92-515

Wizards Workshop

TEKTRONIX INTERNAL USE ONLY

November 21, 1980
Issue 10-23

408, 414 POWER SUPPLY CHANGE

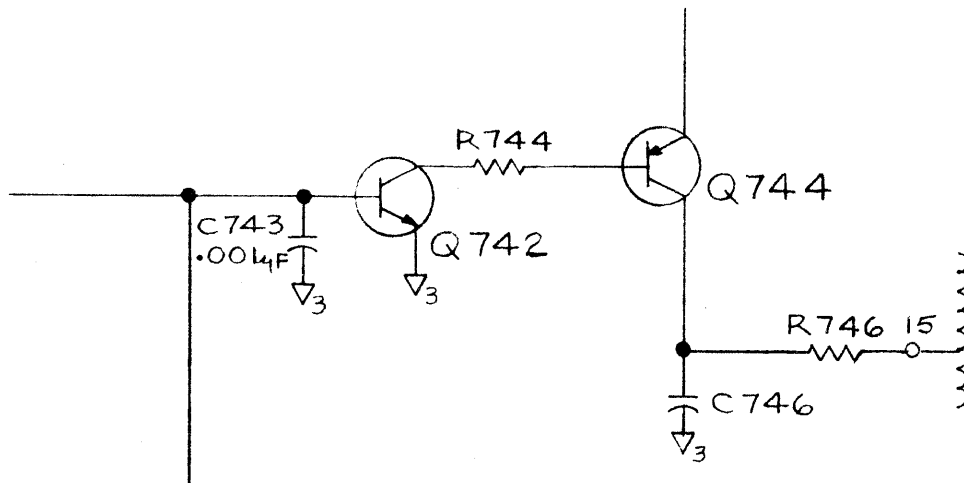
At the below listed serial numbers, the power supply circuitry was changed as shown in the picture below. In this case, the problem was fixed before the new circuit board was ever shipped.

Add: C743 P/N 281-0812-00 0.001 μ F, 10%, 100v

R746 Moved location as shown below.

520 SERIES DIFF GAIN TRACE NOISE

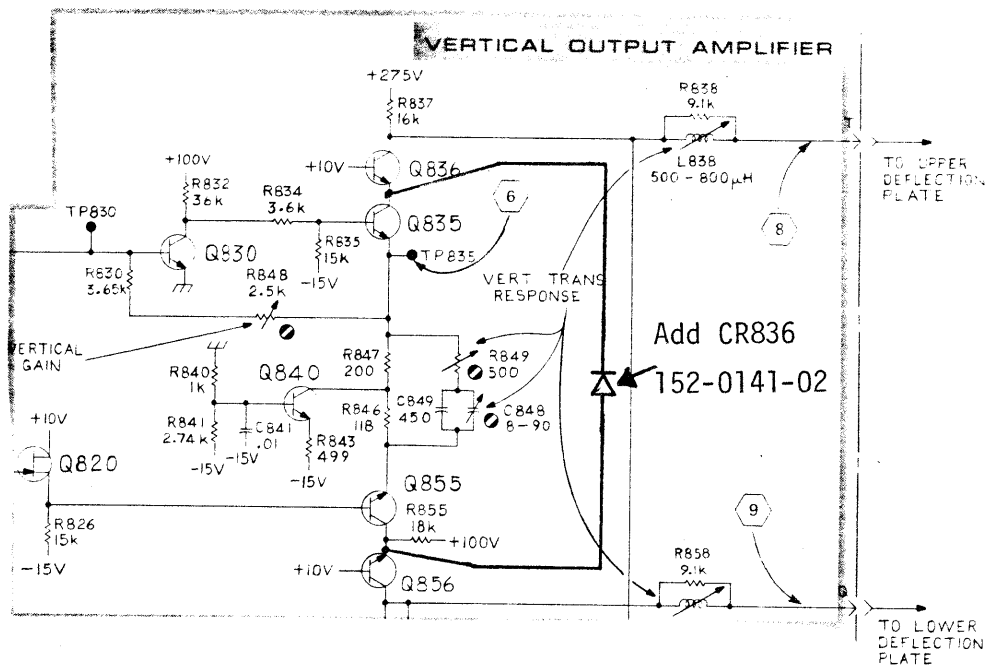
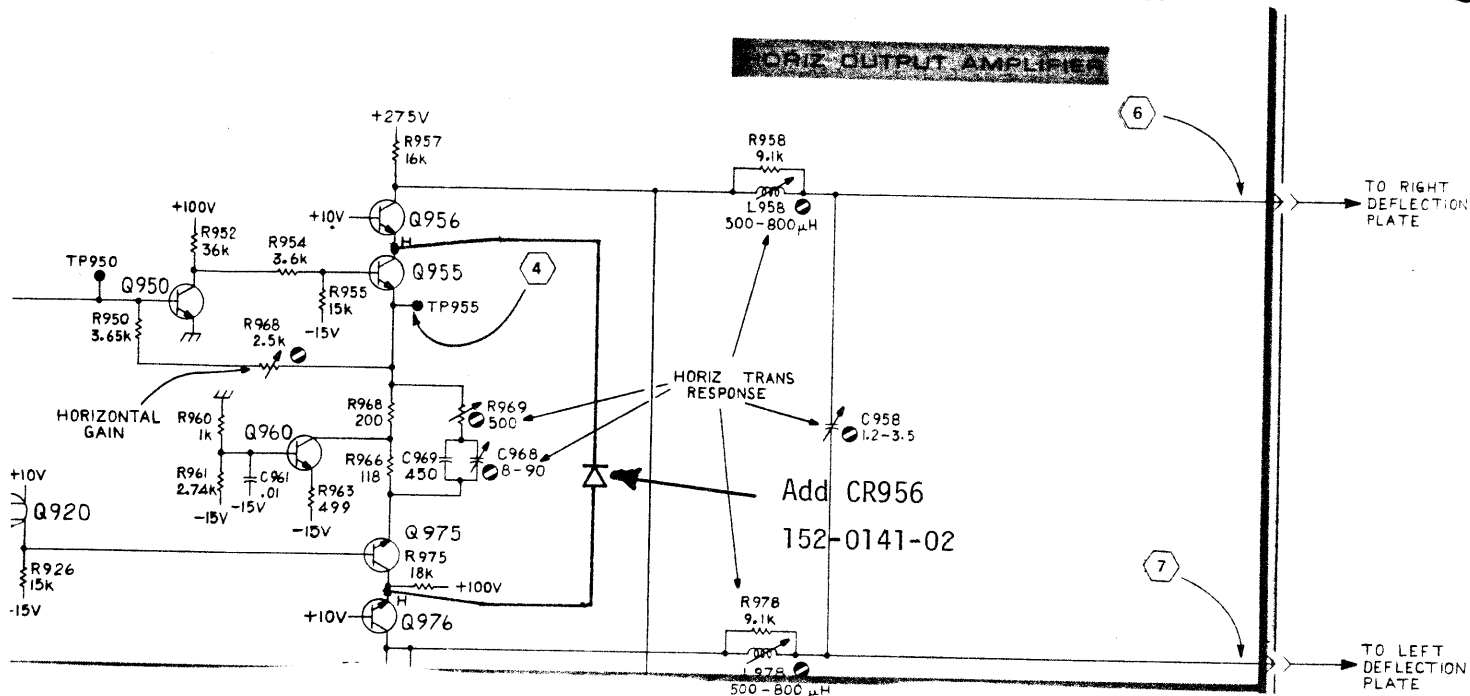
When used in the DIFF GAIN mode, a situation can occur that appears as "noise" on the CRT trace. The reason for this noise is that transistor, Q836, is driven hard into saturation during the vertical interval. During the vertical interval, the clamp Amp samples during each horizontal sync pulse. When Q836 is slow coming out of saturation, the clamp level changes and appears as "noise" on the signal.

To improve circuit operation, a diode (P/N 152-0141-02) is added to the back of the board between the emitter of Q836 and the emitter of Q856, the cathode end going to Q836. This switches the extra current through R855 and Q856 to Q835, thereby relieving Q836 of the extra charge dissipation. The addition of the diode also protects Q856 from being reverse biased into zener break down. Another diode (P/N 152-0141-02) is also added to Q956 (cathode to Q956 emitter) and Q976 (anode to Q976 emitter) on the back of the circuit board, again for reverse break down protection.

Refer to the following diagrams for the additions required.

528 VERTICAL, NOISE ON TRACE (CONTINUED)

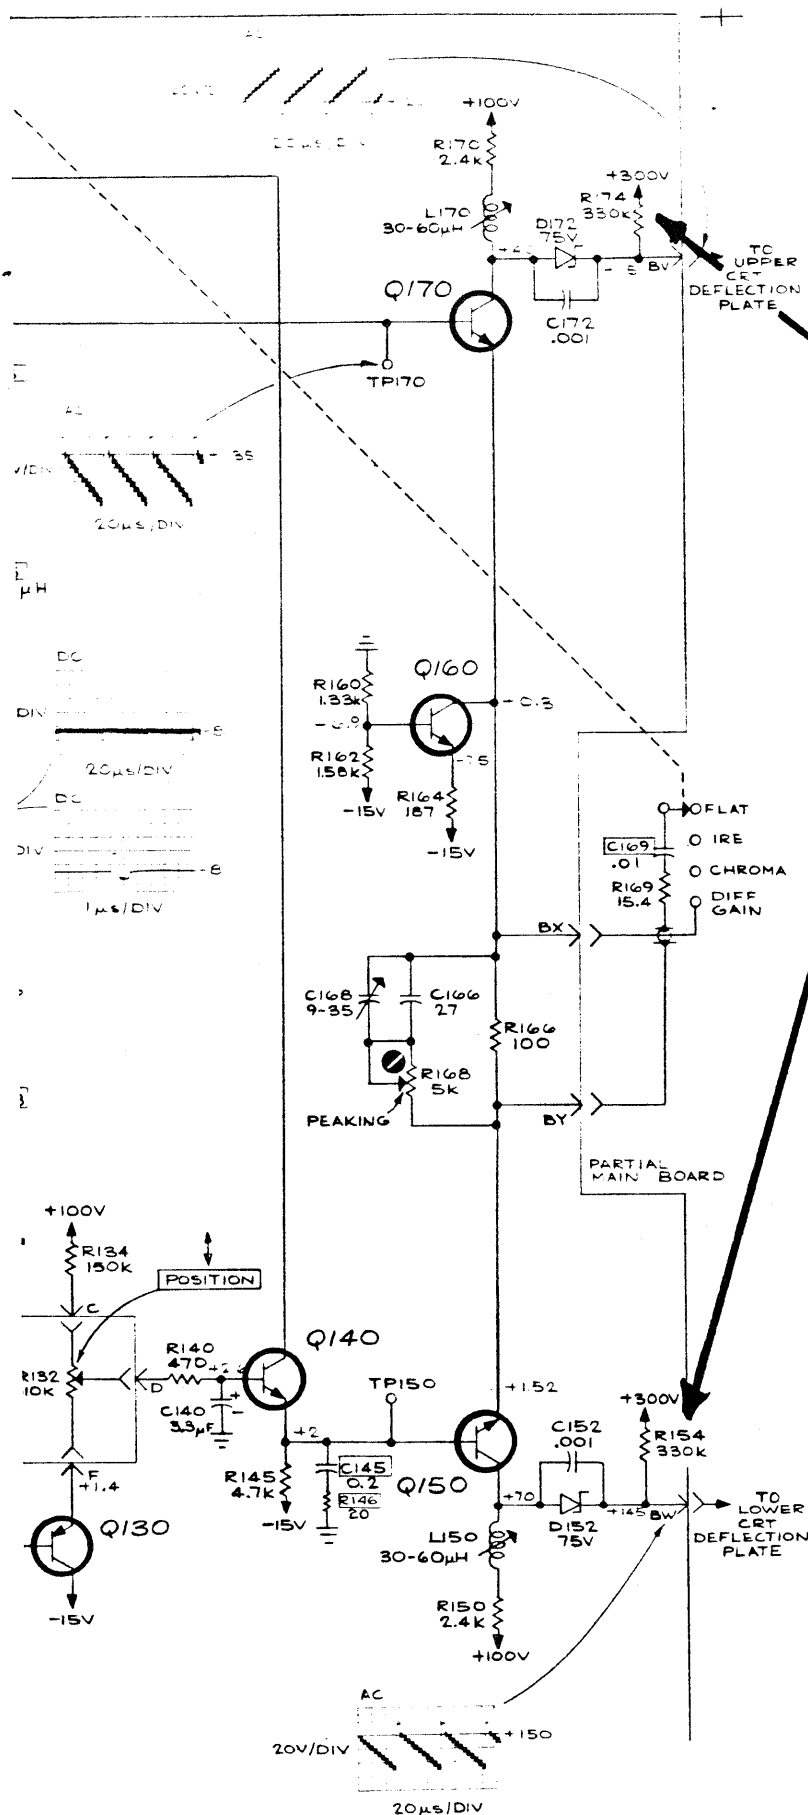
R154, R174

REMOVE 315-0334-00

ADD 323-0408-00

1480 SERIES, D.C. RESTORER, WIZARD CORRECTION

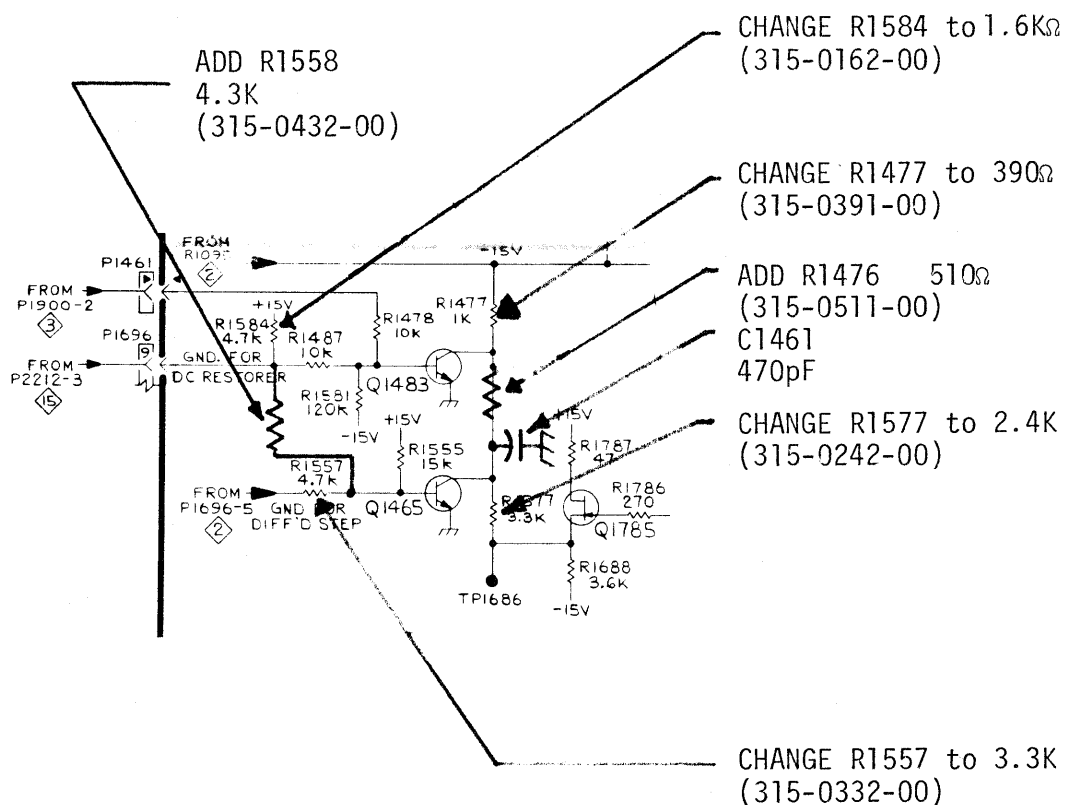
This material is provided to correct an article published in WIZARD'S WORKSHOP, Issue 10-8, April 18, 1980.

The text in the article concerning a modification to improve incomplete D.C. restorer turn-off was correct. The partial schematic that was provided is in error. The proper schematic is illustrated below. The nomenclature is also correct as it is illustrated below:

1980 POWER-UP DIAGNOSTICS (CONTINUED)

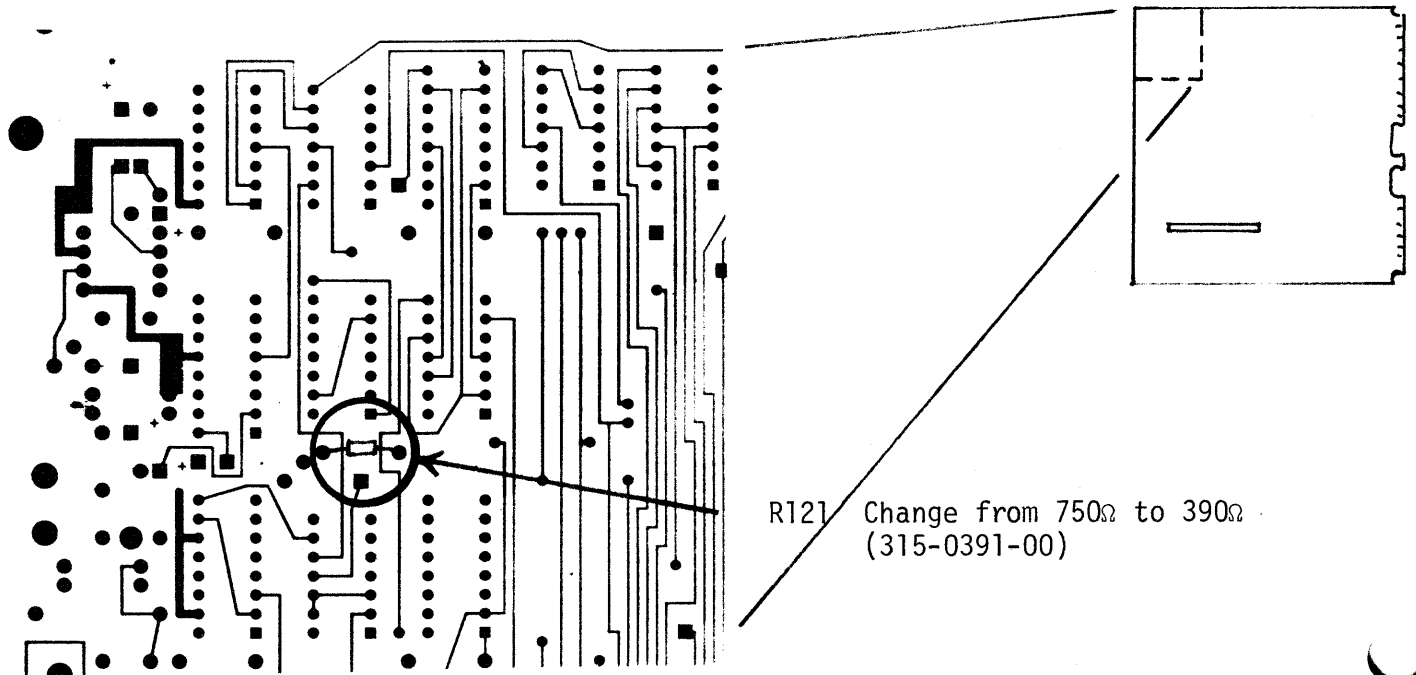
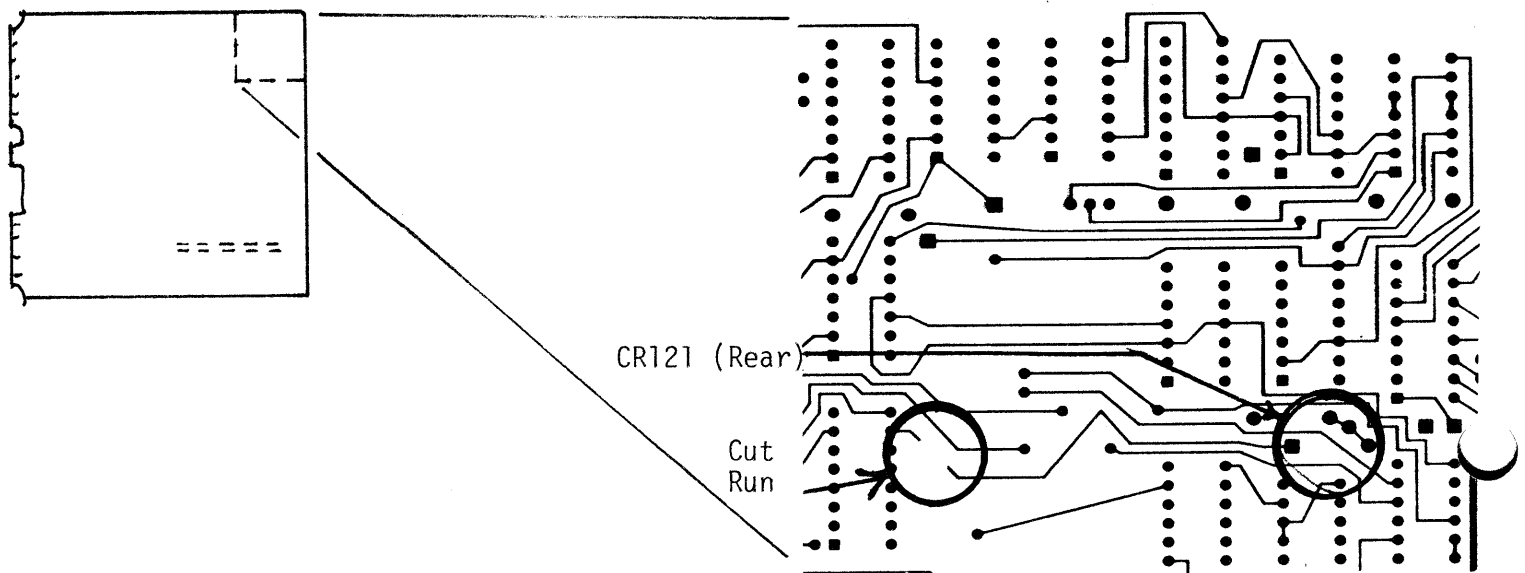
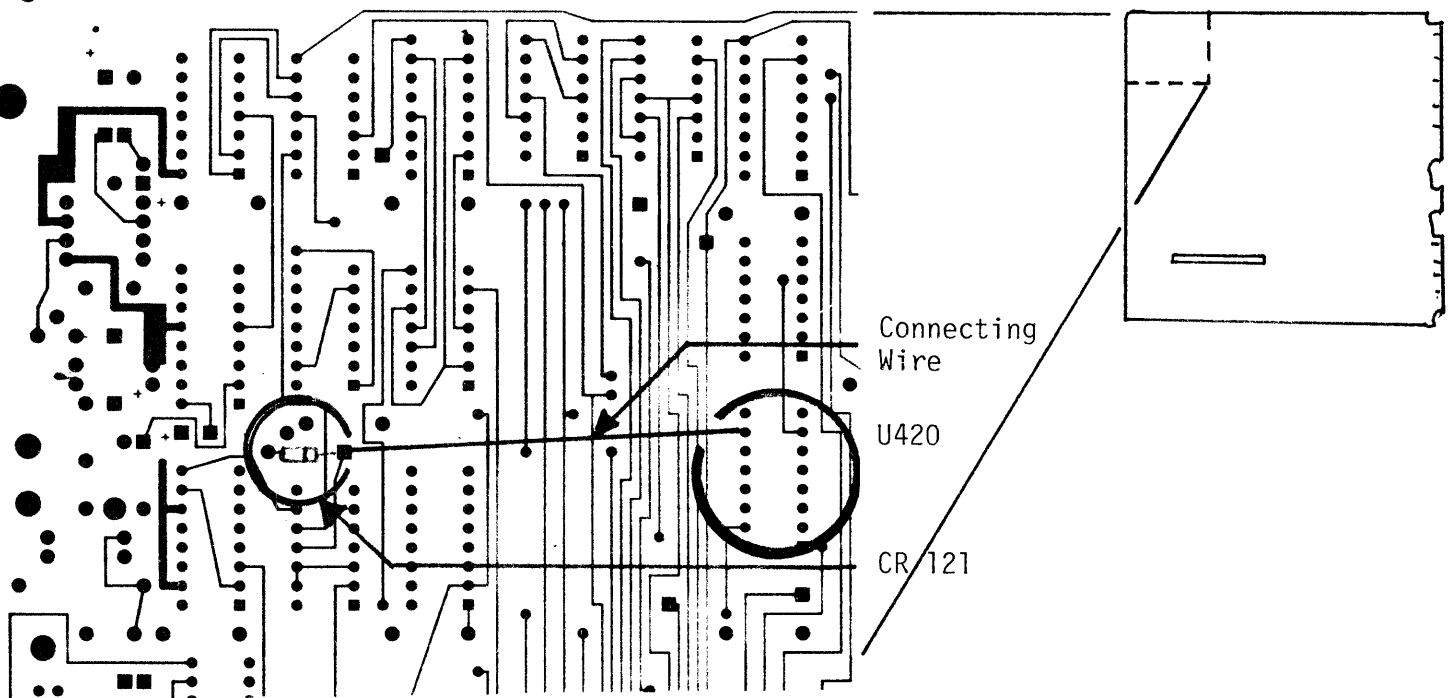
The 1980 will show a power-up diagnostic error in the "VID:" section of the diagnostics if a signal is connected to EXT B SYNC. This is due to an error in the circuit board. All video data converters will have the following modification installed before leaving the factory. Units with S/N B010010180 and below should be modified as they are returned for repair service, or they can be modified on-site on an "as needed" basis.

1. Change R121 from 750 Ω to 390 Ω (315-0391-00).

2. Cut ECB run on rear of circuit board that goes from cathode of CR121 to pin 10 of U420.

3. Clip pin 10 of U420 close to board and CAREFULLY bend the leg of the IC up to clear the board.
4. Connect an insulated piece of wire (3" of #20) from bent up pin (10) of U420 to cathode end of CR121.
